FINAL
ENVIRONMENTAL ASSESSMENT
FOR
BORDER FENCE CONSTRUCTION AND ROAD REPAIR
NACO, COCHISE COUNTY, ARIZONA
JTF-6 OPERATION JT044-94

Prepared for:
Joint Task Force Six
Department of Defense
Fort Bliss, Texas

**FINDING OF NO SIGNIFICANT IMPACT
FOR THE
JOINT TASK FORCE SIX OPERATION JT044-94
BORDER FENCE CONSTRUCTION AND ROAD REPAIR
NACO, COCHISE COUNTY, ARIZONA**

COMMENTS AND RESPONSE LETTERS

Encls
1. Naco Culvert

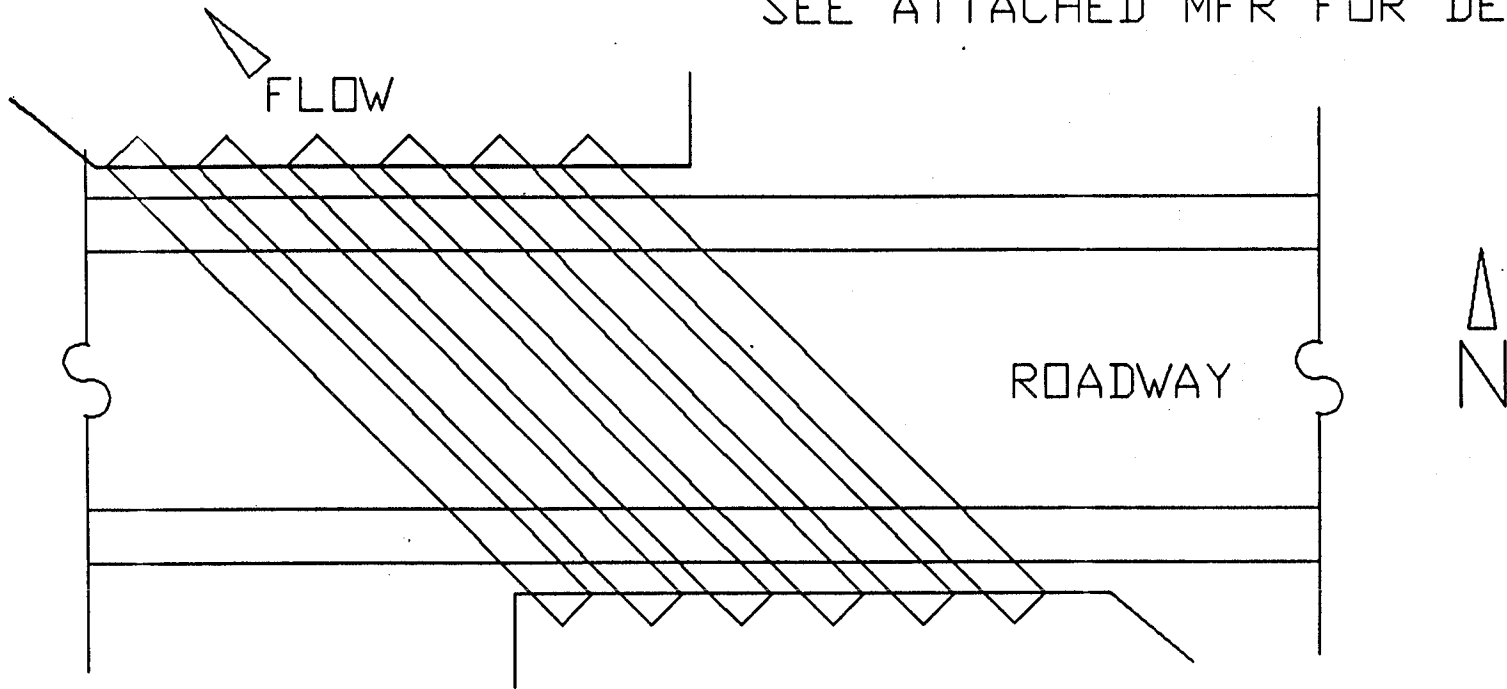
5. Page six of the DEA indicates that drainages along the fence alignment would be cleaned and repaired, and that culverts would be installed (four east of the Port of Entry [POE] and two west of the POE) to prevent the accumulation of water/sewage coming from Mexico while page seven indicates that culverts would be installed as part of road improvements. Please clarify the primary intent of culvert installation, as well as what is meant by "cleaning and repairing" of drainages. The DEA does not indicate how the installation of a culvert would prevent the accumulation of water and sewage. If the culverts facilitate the movement of sewage further into the U.S., there may be several water quality issues which need to be addressed with the Arizona Department of Environmental Quality. Additionally, the Service requests that vegetation removal be minimized.

Thank you again for the opportunity to review and comment on your proposed action. Please send us two (2) copies of the Final Environmental Assessment (EA) when it becomes available and please forward the engineering plans for the culvert installation at your earliest possible convenience.

Response # 3. See JTF-6 letter dated March 22, 1994 to IBWC regarding design of the culvert/erosion control structures. Culverts are installed using design techniques to reduce erosion along the washes i.e. sand bags. Long term cumulative impacts to the drainages due to maintenance will be addressed in the Programmatic Environmental Impact Statement; however, maintenance activity will result in very minor impacts to the vegetation along the washes. Your comment regarding using permeable fills is noted and will be brought to the attention of JTF-6.

- a. 6 - 36" CMP culvert @ 60' long aligned with the nature flow of the wash.
- b. Minimum 18" cover
- c. 18" between CMP
- d. Concrete head walls either formed or bulky angular rubble w/concrete slurry.
- e. Minimum slope = 3.8%

2. All culverts will use bulky rubble w/concrete slurry around head walls and wash area for erosion control. Smaller culverts sited along the road will be constructed using similar erosion control measures. The head and tail walls are designed so that if the capacity of the culvert is exceeded, the water flows over the road with minimal erosion to the roadway.
